**DECLARATION FOR THE EXPLANATION  
OF SIGNIFICANT DIFFERENCES  
OTTATI AND GOSS / KINGSTON STEEL DRUM  
SUPERFUND SITE  
September 28, 1999**

Ottati and Goss / Kingston Steel Drum  
Operable Unit 4  
Kingston, New Hampshire

**EXPLANATION OF SIGNIFICANT DIFFERENCES  
 OTTATI AND GOSS / KINGSTON STEEL DRUM SUPERFUND SITE**

OTTATI & GOSS / KINGSTON STEEL DRUM  
 SUPERFUND SITE KINGSTON, NH  
 MODIFIED REMEDY 1999  
 EXPLANATION OF SIGNIFICANT DIFFERENCES

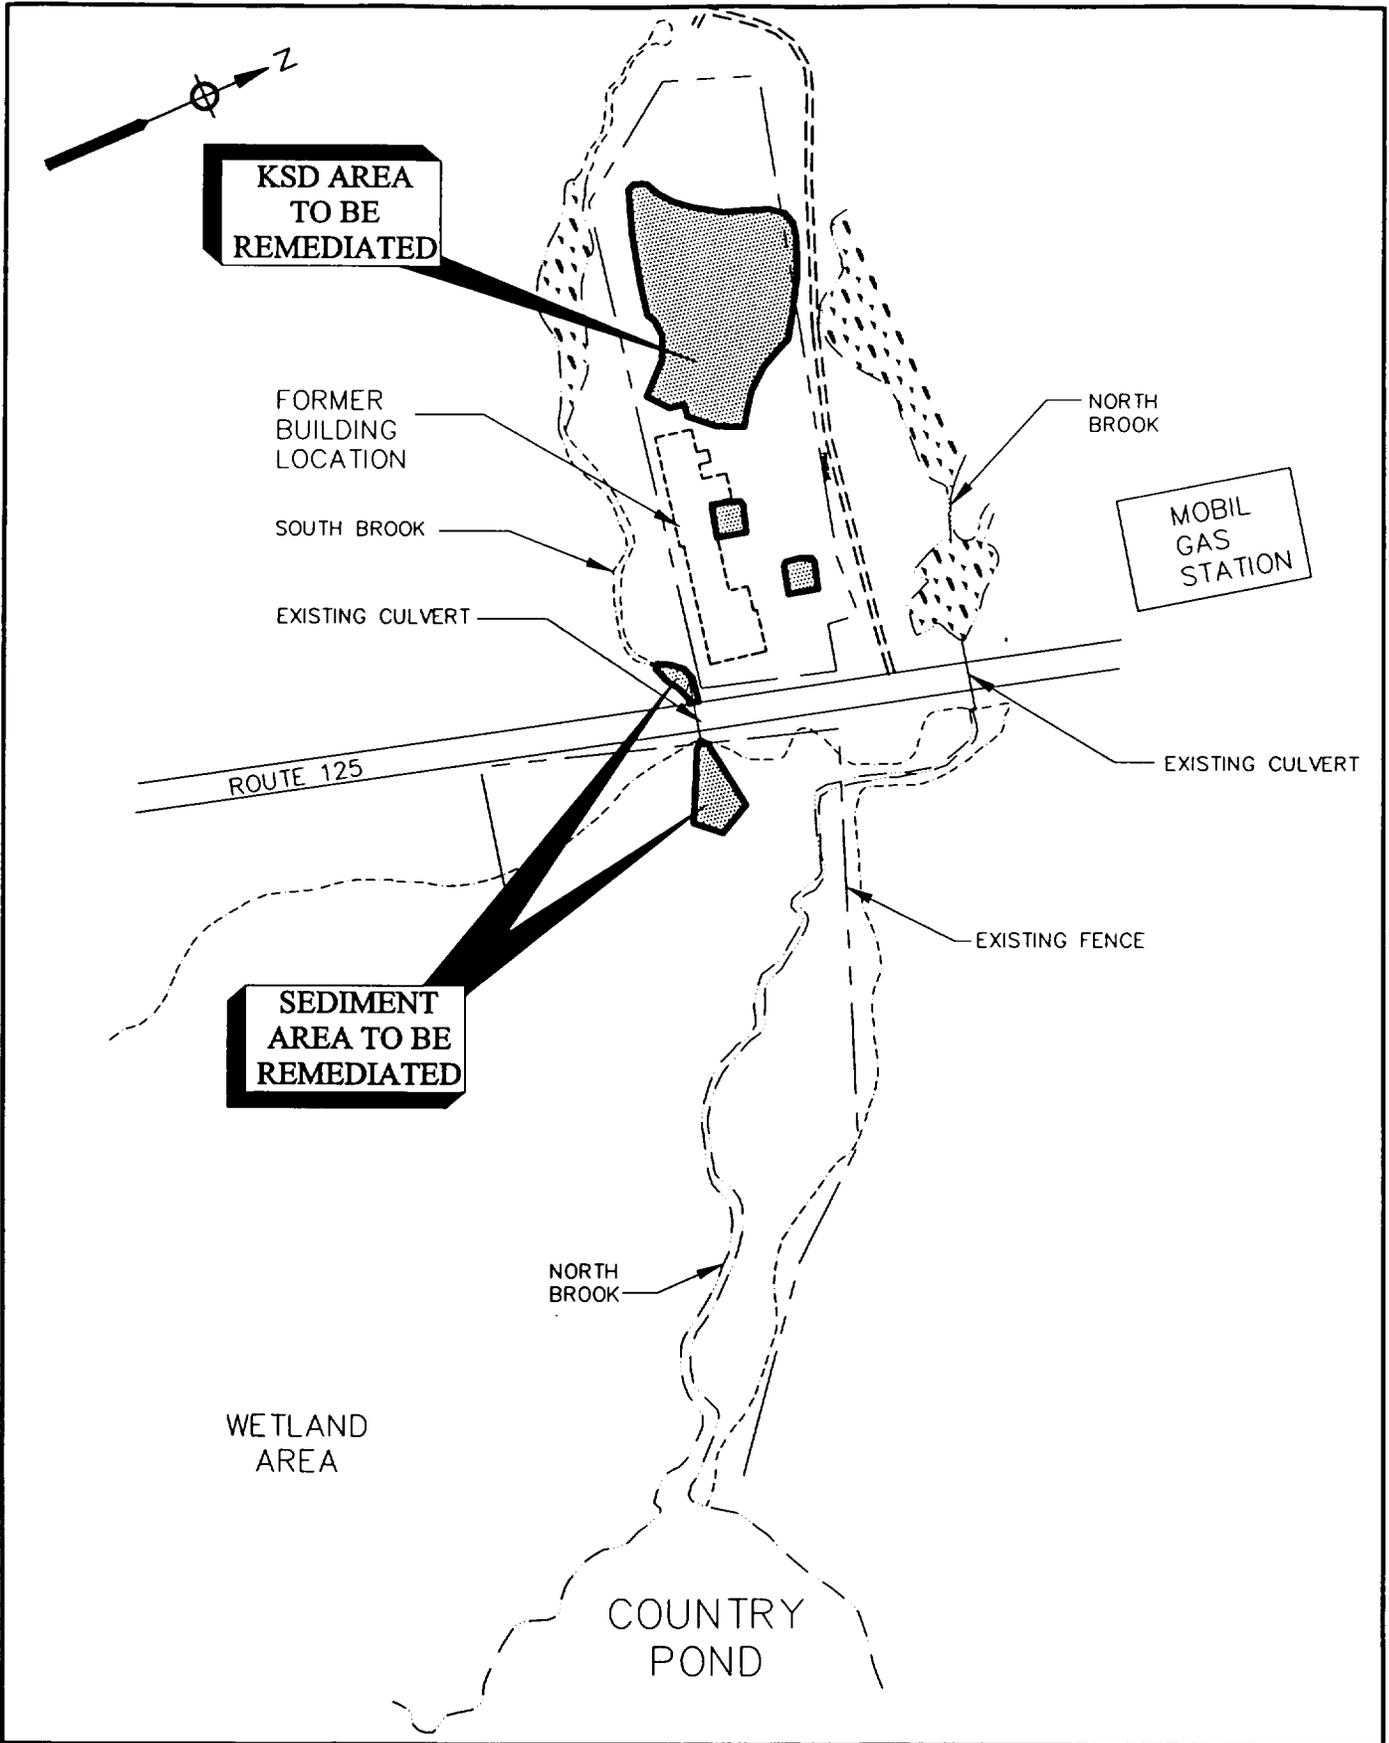
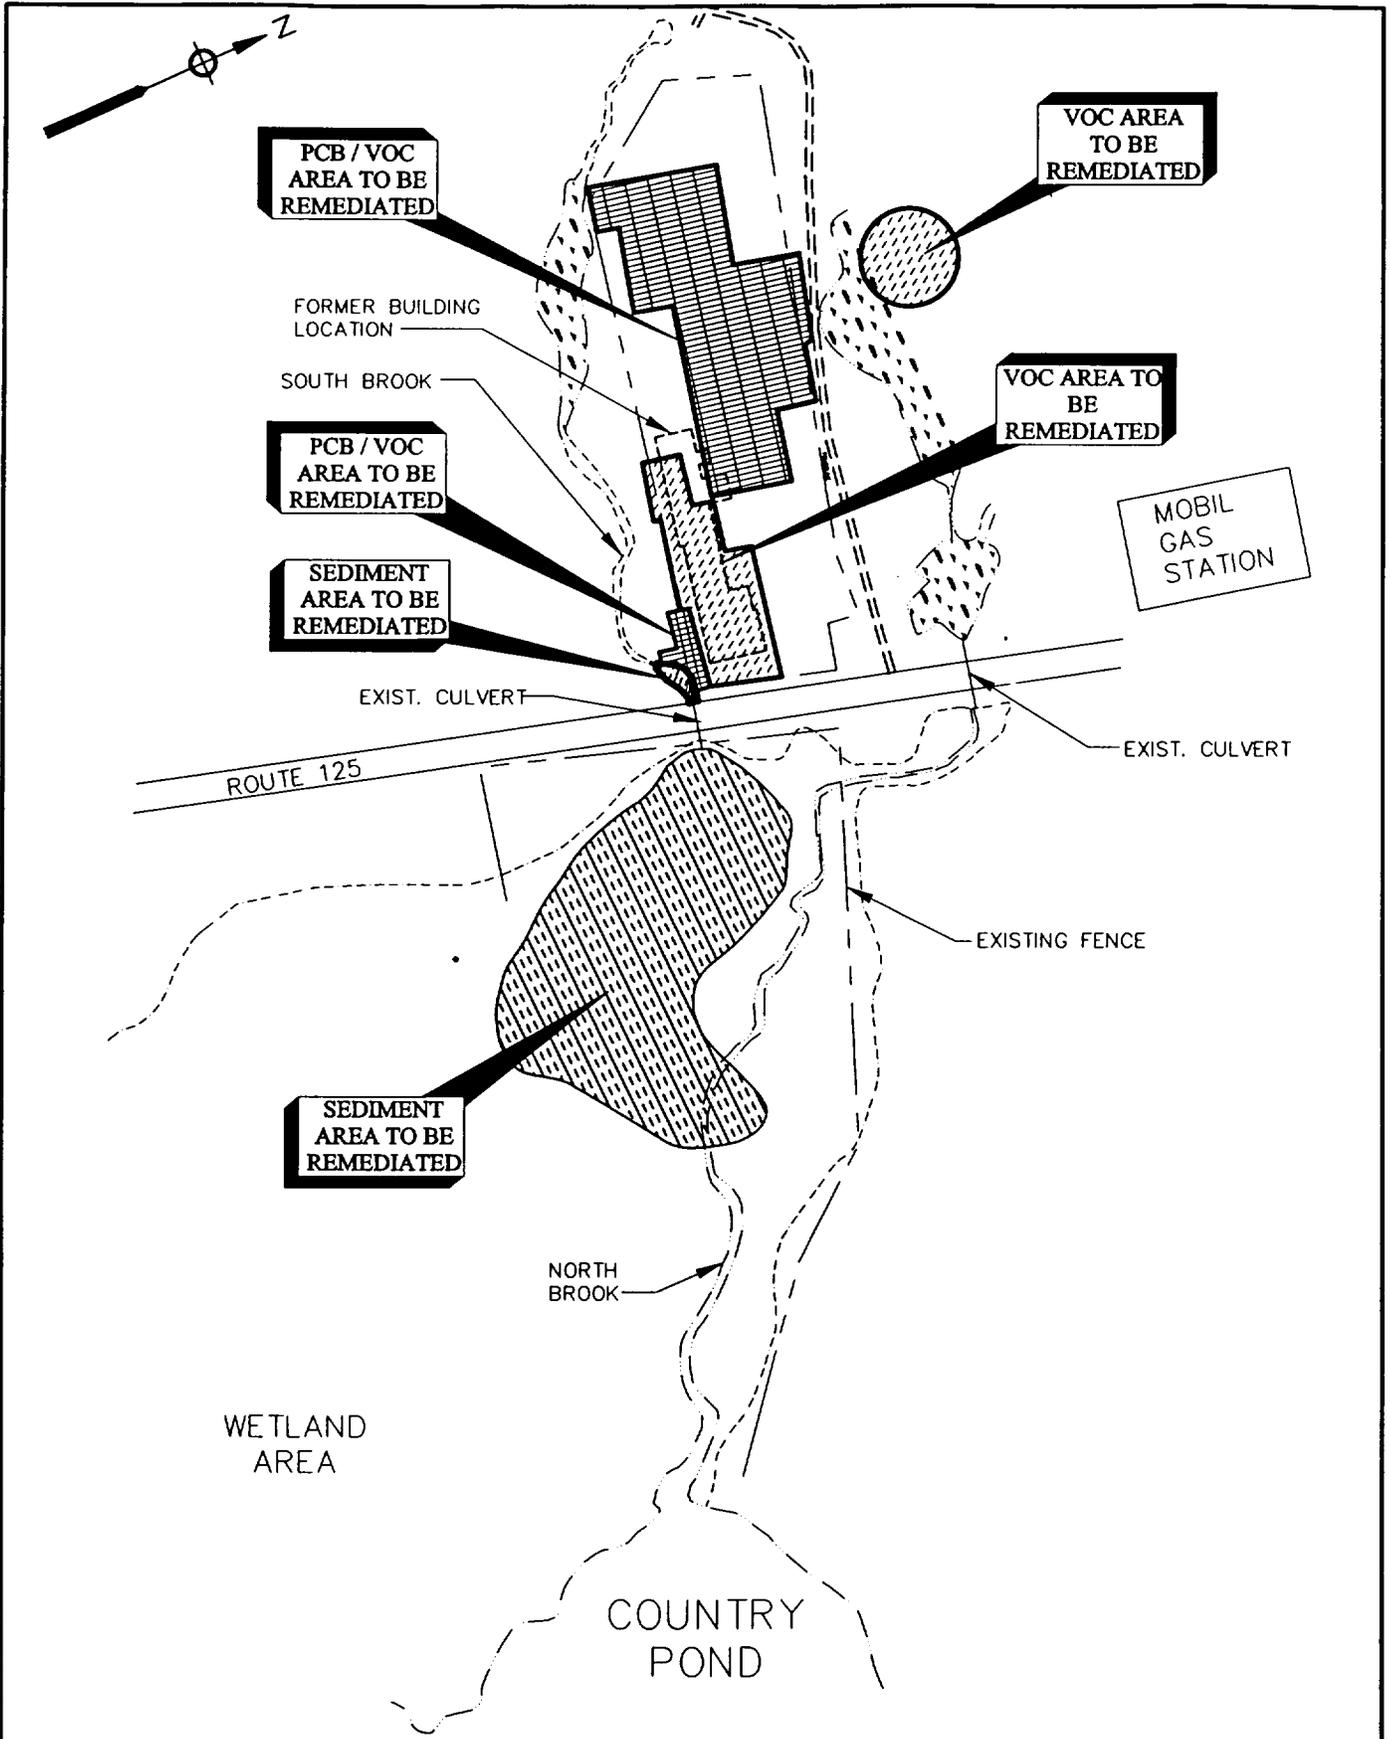
Soil remediation of 4700 cy in the O&G area and removal of the building in the KSD area has already been completed. The removal of the building and underground tanks located under the building in the KSD area has revealed additional soil material contaminated by past operations. The design investigation has found that contamination in fill material located under and behind the building needs to be excavated and treated. The total volume of soils presently estimated for remediation in the KSD portion of the site is 14,000 cy. Of this total, 7,650 cy has PCB / VOC contamination and 6,350 cy has only VOC contamination. The table in the Section below shows the changes in volumes. The cost of soil remediation (not including the wetland remediation of 10,000 cy of sediment) under the modified remedy is approximately \$9.5 million. See Figure 3 for the areas to be remediated in the KSD area of the Site.

The design studies, using better sampling and analytical techniques than those used during the RI/FS for the Site, have found PCB contaminated sediment in the wetland over a widespread area. The concentrations of PCBs decrease as distance from the culvert exit increases.

A site specific Ecological Assessment (EA) in cooperation with the US Fish and Wildlife Service (USFWS) was performed following the RI/FS because the ecological risk assessment in the RI/FS proved insufficient for designing a cost effective remediation. The EA used deterministic and probabilistic methods for modeling ecological risks, and spatially weighted average total PCB concentrations in the marsh to estimate residual risks from contamination that might remain after focused remediation. Species specific, PCB risk reduction curves for alternative total PCB clean up goals of 1 or 10 mg/kg were used to draw conclusions. The EA concluded that 70% of the total PCBs sediment risk could be eliminated (resulting in a hazard quotient of < 1.5 throughout the 60 acre marsh) if brook and wetland sediments exceeding 10 mg/kg in a five acre area were remediated. See Figure 3 for the area to be remediated in the wetland.
